### VILLAGE REVIEW BOARD

#### REVISED\* AGENDA

### DRAFT FINDINGS OF FACT REQUEST FOR CERTIFICATE OF APPROPRIATENESS FOR ADDITIONS AND ALTERATIONS VILLAGE REVIEW BOARD

**PROJECT NAME:** 16 Dunlap Street Enclosed Porch

View from Bank Street

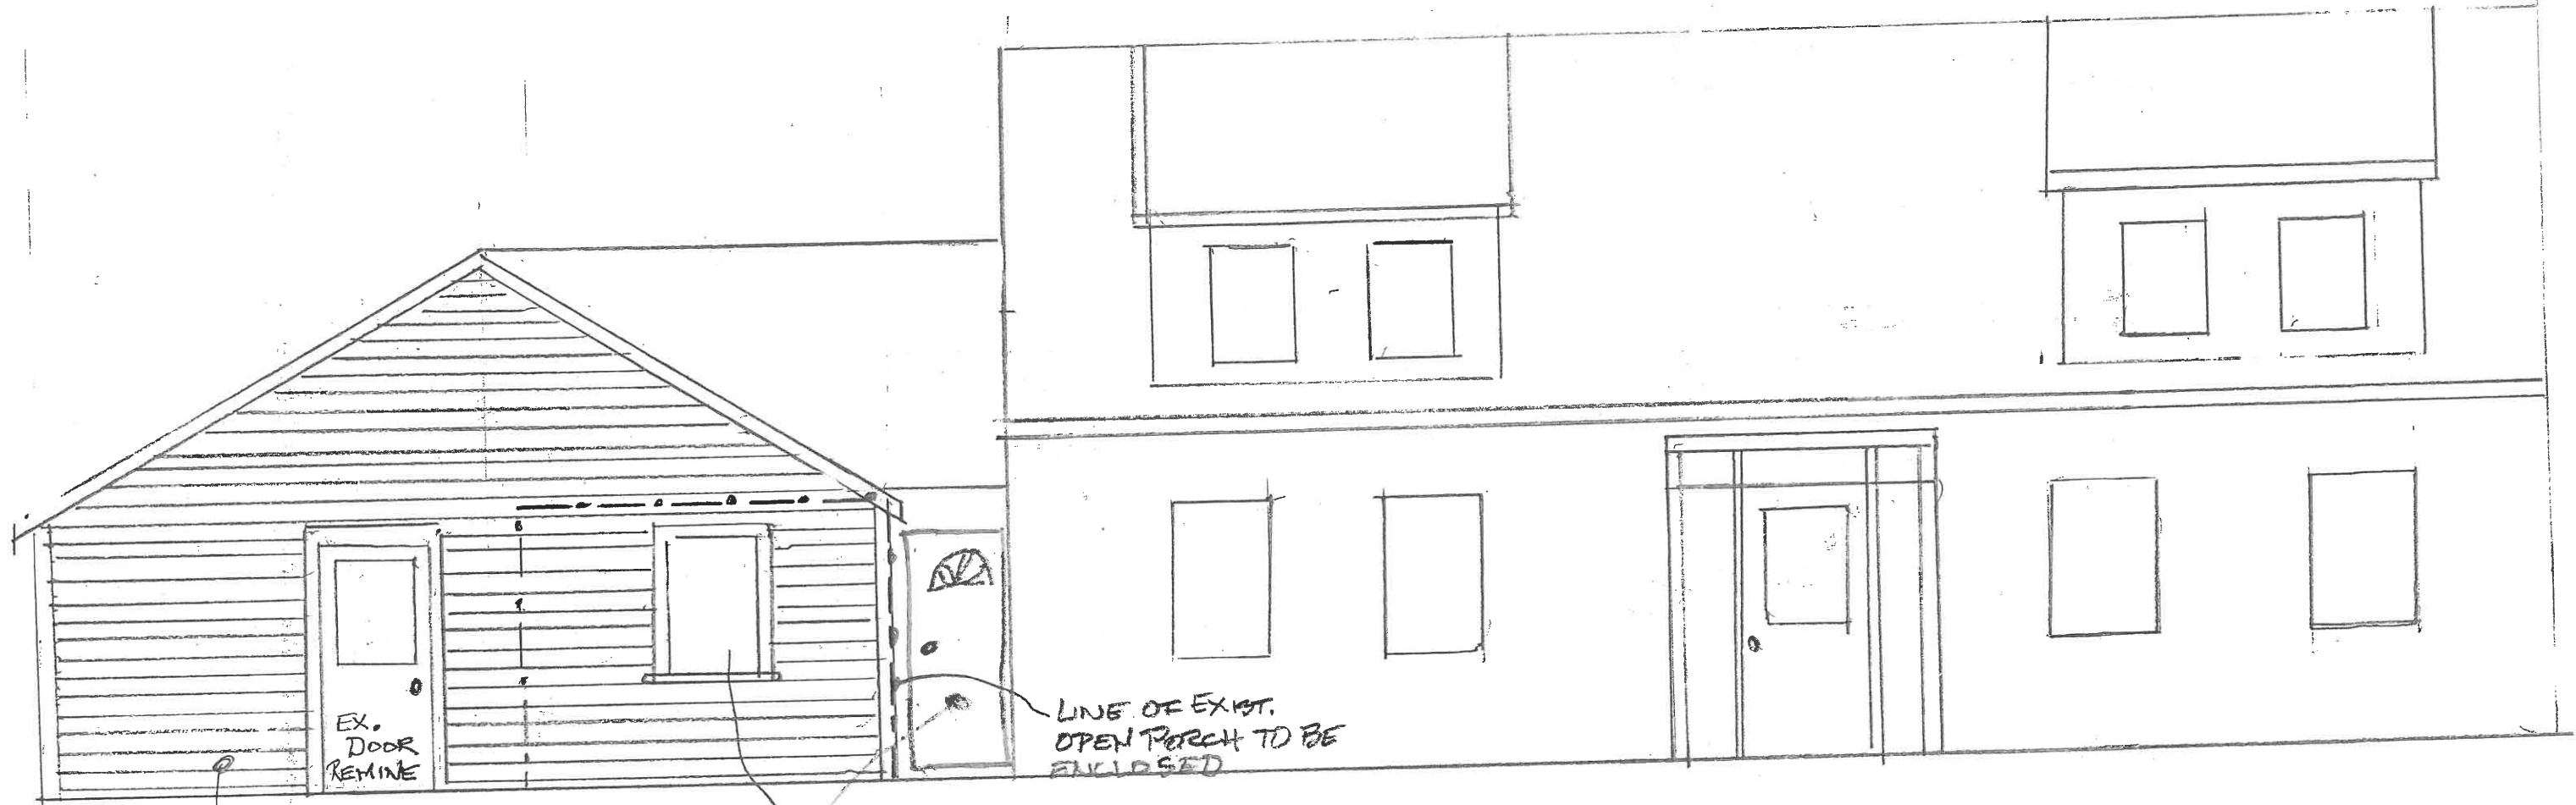
The *Village Review Overlay District Design Guidelines* stipulate that enclosing an existing porch on the *primary* building façade should be avoided. The subject porch is at the rear of the structure on a seemingly later addition to the building that lacks architectural character. No significant details will be lost in the construction of the proposed project.

As noted, the subject porch is at the rear of the structure on a seemingly later addition to the building that lacks architectural detail. The proposed changes do not affect the historical integrity of the resource.

The alterations will remain visually compatible with the streetscape. The proposed project is within the existing footprint of the building and toward the rear of the structure. The addition will include the same white vinyl siding as the remainder of the building which is compatible with neighboring properties.

The proposed alterations are within the existing footprint of the building and does little to affect the mass of the building. The existing height of the structure will be maintained.

Vinyl siding is listed as a potentially acceptable substitute siding material within the Village Review Overlay District Design Guidelines as it “evokes the horizontal emphasis of clapboards”. The majority of properties along Dunlap Street are vinyl sided.

The applicant has indicated that the proposed window will be a gridless vinyl window to match the existing windows. Vinyl replacement windows are also common in the contributing structures along Dunlap Street.

**Motion 2:** That the Board approves the **Certificate of Appropriateness for New Construction** to enclose a rear porch on the structure located at 16 Dunlap Street, Map U13, Lot 141; as outlined in the application and as satisfied by Subsection 5.2.8.C with the following condition(s):
